## RE: Aspect Industrial Estate Modification 2 – SSD 10448 Proposed Mod 2 – Response to Submissions

We refer to the relevant submissions received in relation to the aforementioned State Significant Development (SSD-10448-Mod-2<sup>1</sup>). Reference is made to the submissions by Penrith City Council (Council, dated 24 August 2022). A summary of the relevant traffic and access comments, and the Ason Group response is provided below.

**TABLE 1: RESPONSE TO COUNCIL COMMENTS**

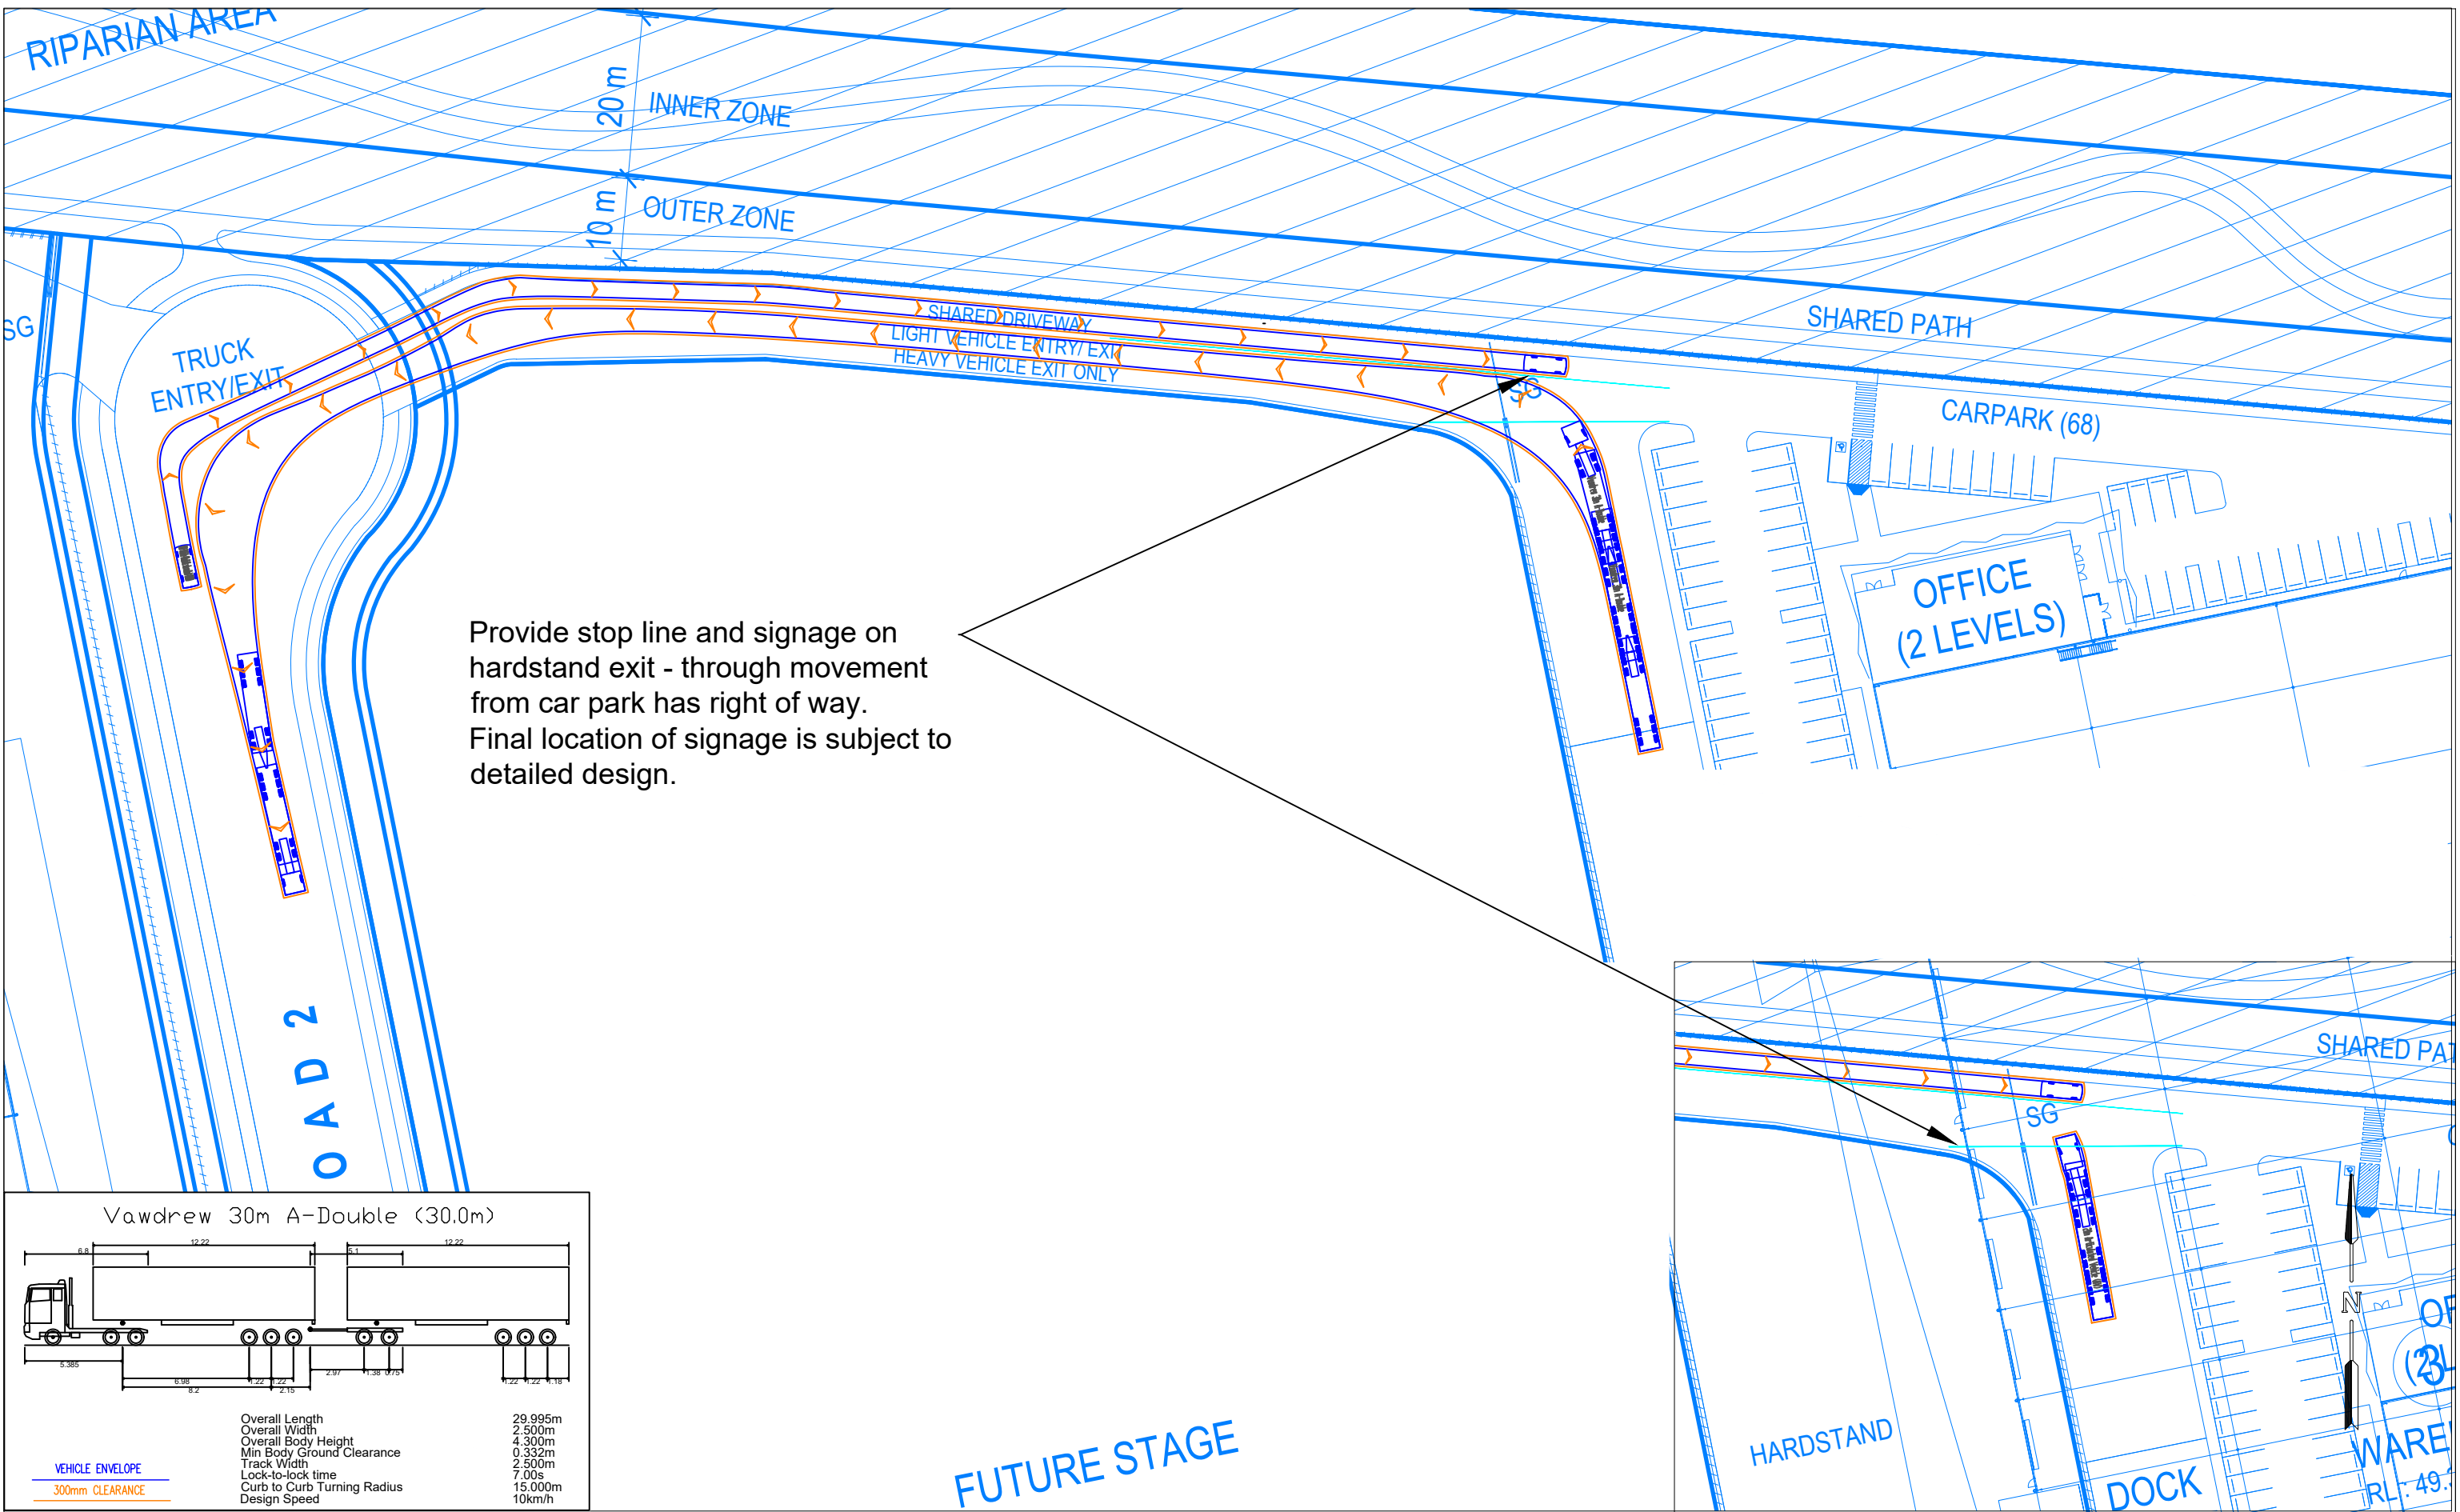
Council Comment	Ason Group Response
<b>2. Planning Considerations</b>	
<b>2 (b)</b> – it is reiterated that heavy vehicles be fully separated from staff and visitor vehicles	<p>The Site has been designed in compliance with the requirements of AS289.1:2004 and AS289.2:2018, as required by the Mamre Road Development Control Plan.</p> <p>Shared access by cars and trucks is permitted under the relevant Australian Standards. Indeed, Section 3.3.2 of AS289.2:2018 makes provision for car parking on circulation roadways used by trucks and other commercial vehicles.</p> <p>It is only the “service area” – where trucks are reversing – that should be separated from car parking areas and pedestrian activity, as per Section 4.1 of AS289.2:</p> <p><i>The design of <b>service areas</b> should provide separation from areas of car parking, pedestrian activity, entrances and exits.</i></p> <p>The driveway would operate in a manner consistent that of any roadway, with the light and heavy vehicle accesses off of the main driveway, into separated car parking and hardstand areas. Therefore, there would be no conflict between light vehicles parking, and heavy vehicles manoeuvring in and out of loading bays.</p> <p>This approach has minimised the access driveways from the internal precinct road whilst maintaining the efficiency and safety of Warehouse 2 and 3 and therefore, the design is considered appropriate.</p>

<p>The proposed internal circulation roadways for Warehouse 3 shared between passenger vehicles accessing the carpark and heavy vehicles accessing the hardstand this is not supported on safety grounds.</p> <p>Swept path assessments were not included in the Appendix of the updated traffic report and in this respect DPE should request and review.</p>	<p>As above, see response to <b>Item 2 (b)</b>.</p>

<p>The shared driveway will be for truck exit only. The flow through the hardstand will be line marked and signposted accordingly to ensure no heavy vehicles utilise this point to enter the Site. Further, at the internal point of exit from the hardstand to the driveway, “stop” line marking and signage is to be provided to ensure that light vehicles exiting the car park have priority.</p> <p>This will form part of the signage design requirements, which is detailed prior to the occupation. It is anticipated that this could be ensured via a suitable Condition of Consent, to be prepared by a suitably qualified consultant during detailed Construction Certificate design coordination.</p> <p>Further to the above, a minor change has been made to layout, to ensure that the exiting heavy vehicle would not cross over the centre of the driveway. Thus, therefore would be no conflicts between light and heavy vehicles.</p> <p>Swept path analysis for Warehouse 3 on the updated masterplan is annexed in <b>Appendix A</b> (see Sheet AG06).</p>
